DEPARTMENT OF THE AIR FORCE
HEADQUARTERS 377TH AIR BASE WING (AFMC)

Subject: **Kirtland Air Force Base Bulk Fuel Facility – Groundwater Extraction Pilot Implementation and Additional Plume Characterization Letter Work Plan Addendum–Final**

Proposed Amendments to the August 1, 2014 Work Plan and Approval Conditions of August 20, 2014

Figure 1. Screen Approval Form
Monitoring Well Completion Diagram KAFB-_____

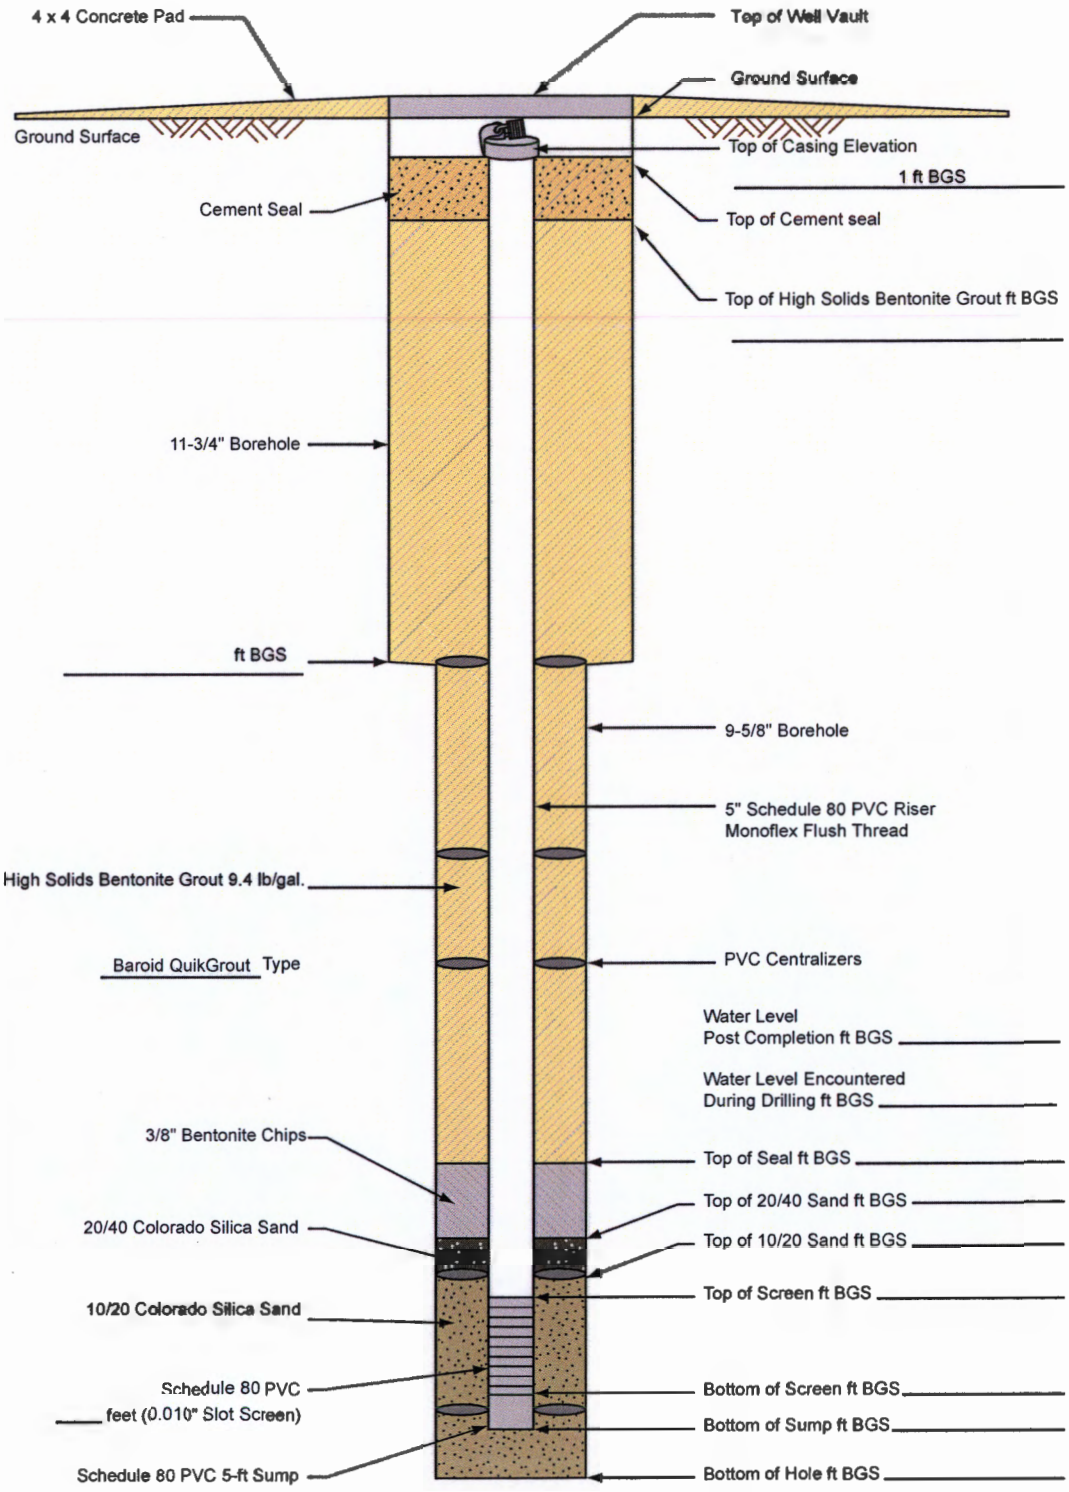
"For each of the additional 15 monitoring wells the Permittee shall provide a lithologic log and proposed screened interval to NMED for approval. NMED will provide a list of staff who will be available to receive, review and approve this information during drilling operations."

The NMED will be notified two days prior to drilling and notified on the day an individual boring is completed. Upon reaching the total depth of the well, a qualified NMED representative will be available in the field to review the lithologic log and proposed screen interval for the well, and sign the screen interval approval form. Based on discussion with NMED, it is anticipated that the proposed screen interval will be approved or disapproved by the NMED field representative within 1 hour of its receiving the documents. If the screen interval is not approved, a decision will be made in the field to either set the screen higher, or drill the well slightly deeper to set the screen lower. See Figure 1 for the Screen Approval form.

The NMED will be notified two days prior to drilling and notified on the day an individual boring is completed. In accordance with Condition #3 in the August 20 NMED approval letter (NMED, 2014), upon reaching the total depth of the well, a qualified NMED representative will be available in the field to review the lithology log and proposed screen interval for the well, and sign the screen interval approval form. Based on discussions with NMED, it is anticipated that the proposed screen interval will be approved or disapproved by the NMED field representative within 1 hour of receiving the documents. If the screen interval is not approved, a decision will be made in the field to either set the screen higher, or drill the well slightly deeper to set the screen lower. See Figure 1 for the Screen Approval form.

The NMED will be notified two days prior to drilling and notified on the day an individual boring is completed. In accordance with Condition #3 in the August 20 NMED approved letter (NMED, 2014), upon reaching the total depth of the well, a qualified NMED representative will be available in the field to review the lithologic log and proposed screen interval for the well, and sign the screen interval approval form. Based on discussion with NMED, it is anticipated that the proposed screen interval will be approved or disapproved by the NMED field representative within 1 hour of its receiving the documents. If the screen interval is not approved, a decision will be made in the field to either set the screen higher, or drill the well slightly deeper to set the screen lower. See Figure 1 for the Screen Approval form.

FIGURE 2

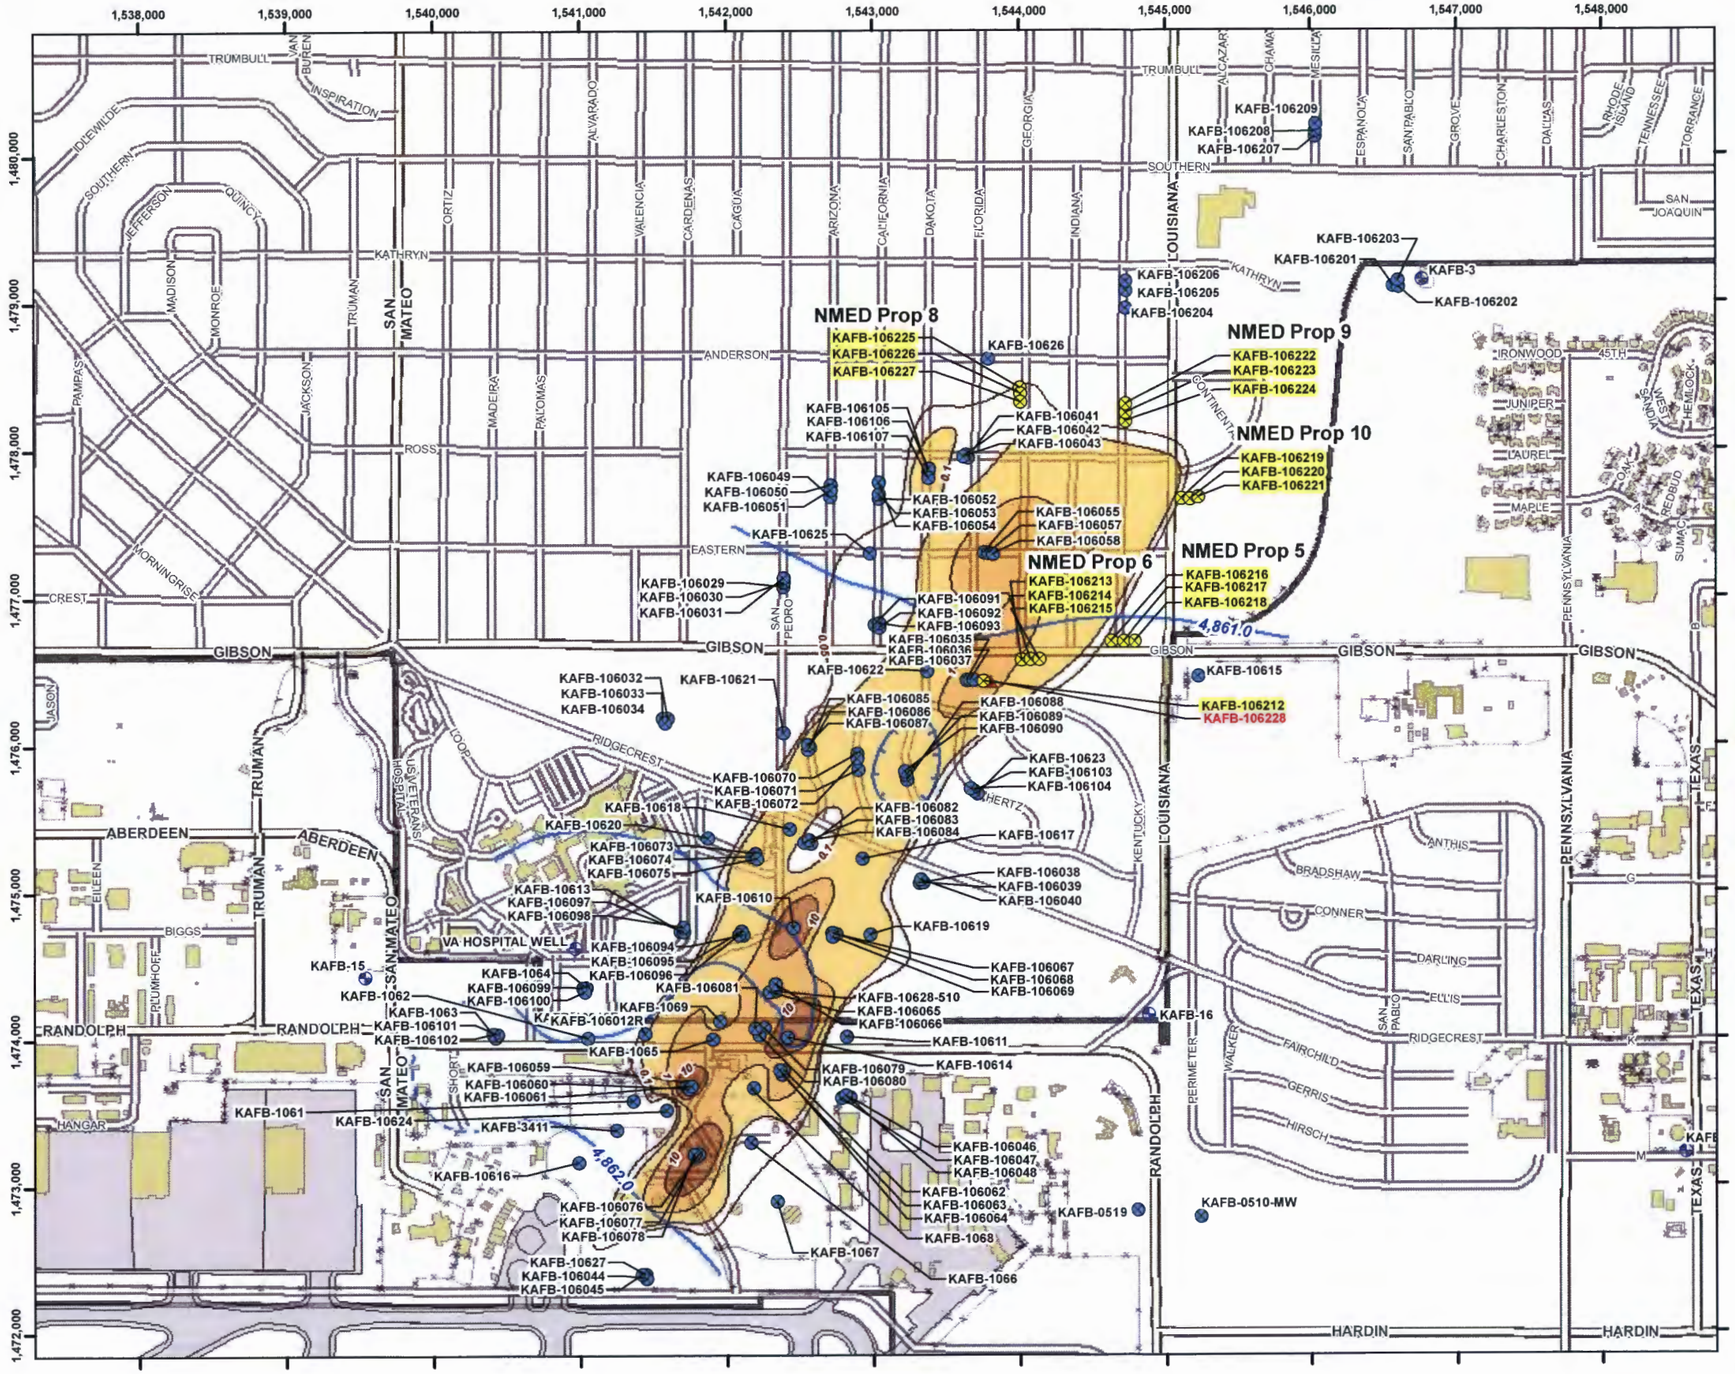
"For each of the additional 5 monitoring well nests the Permittee shall provide a written work plan describing the anticipated depth to groundwater, lithology and contamination conditions based on the results obtained from well KAFB-106212 and other wells in the area. These drilling work plans shall become part of the work plan approved by this letter."

Additional detail regarding well installation, requested in the August 20, 2014 meeting with NMED, is provided below. See Figure 2 for a map of proposed locations.
